Site Investigation Work Plan

NYSDEC Site #828196

Re: 68-92 Genesee Street
Rochester, New York 14611
NYSDEC Site 828196
Site Investigation Work Plan
LaBella Project No. 2182888

LaBella Associates, D.P.C. (LaBella) is pleased to submit this response on behalf of the City of Rochester to the Department's comment letter dated February 21, 2020 on the revised Site Investigation Work Plan dated January 2020 for 68-92 Genesee Street. Responses are provided in bold font.

FIGURE 6

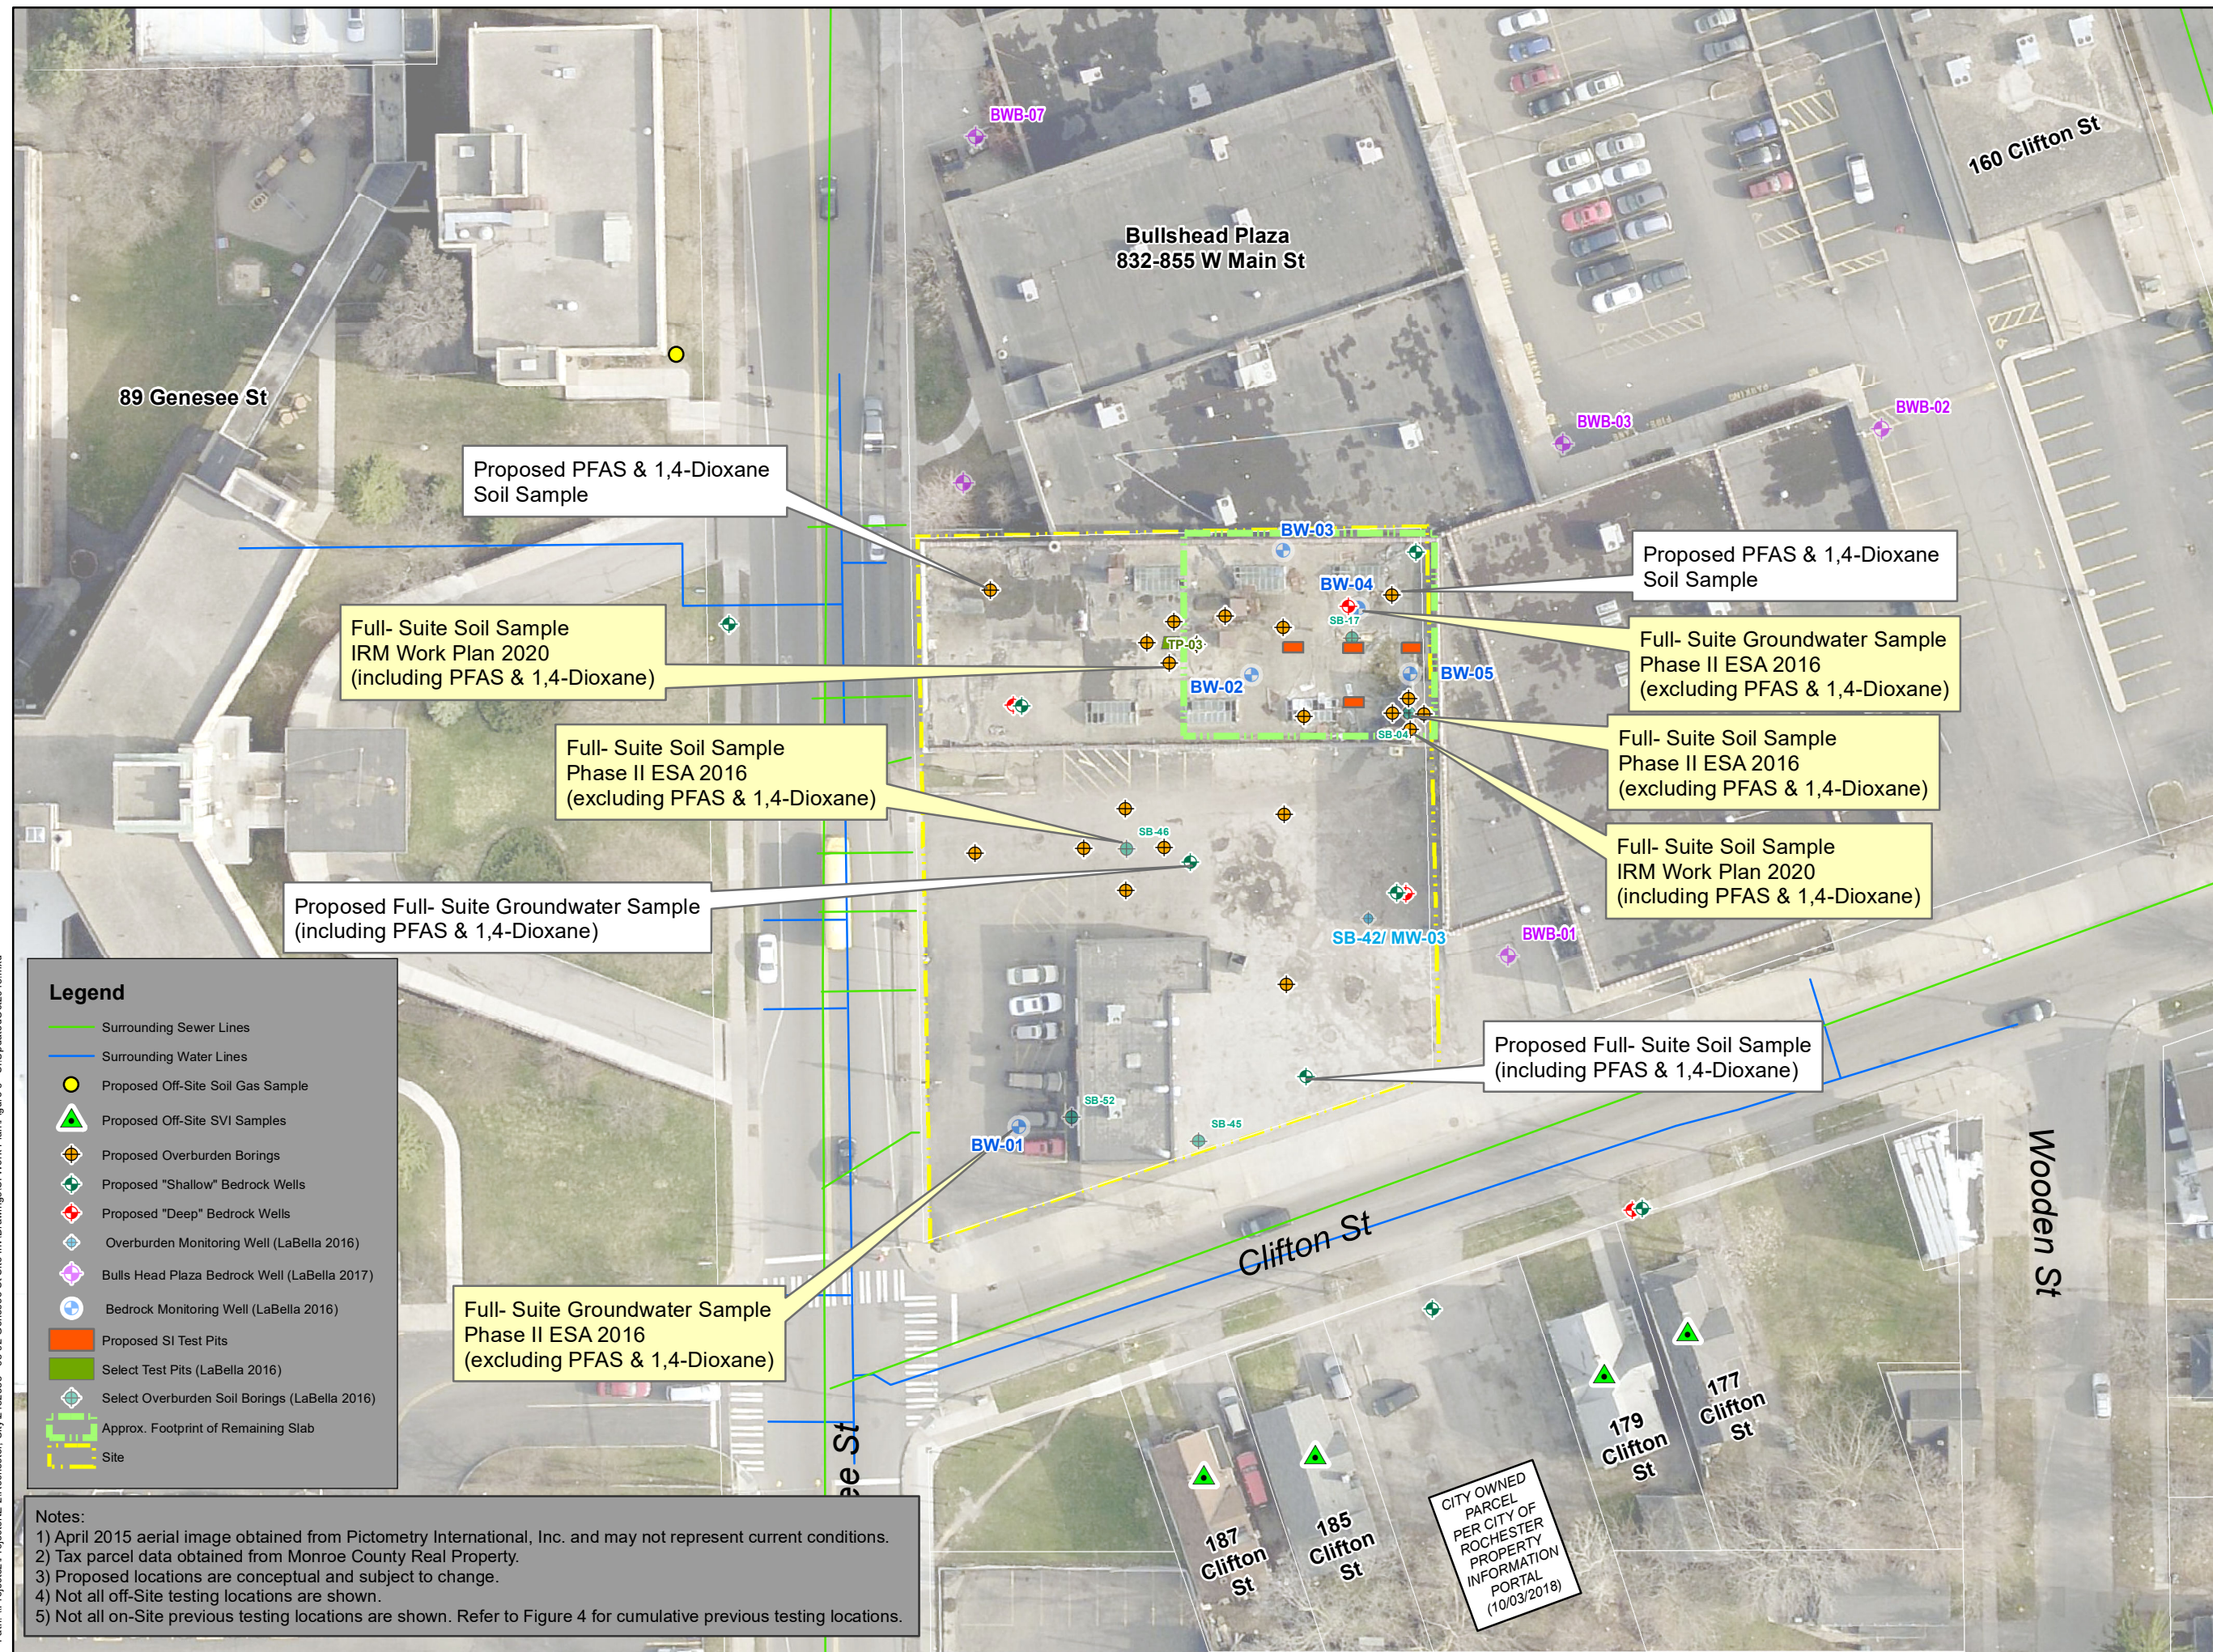
1. Please identify the locations of the full suite groundwater and soil samples added to the work plan, as well as the locations of the two soil samples being collected for emerging contaminants. **Refer to Figure 6 for sample locations for full-suite and emerging contaminants.**
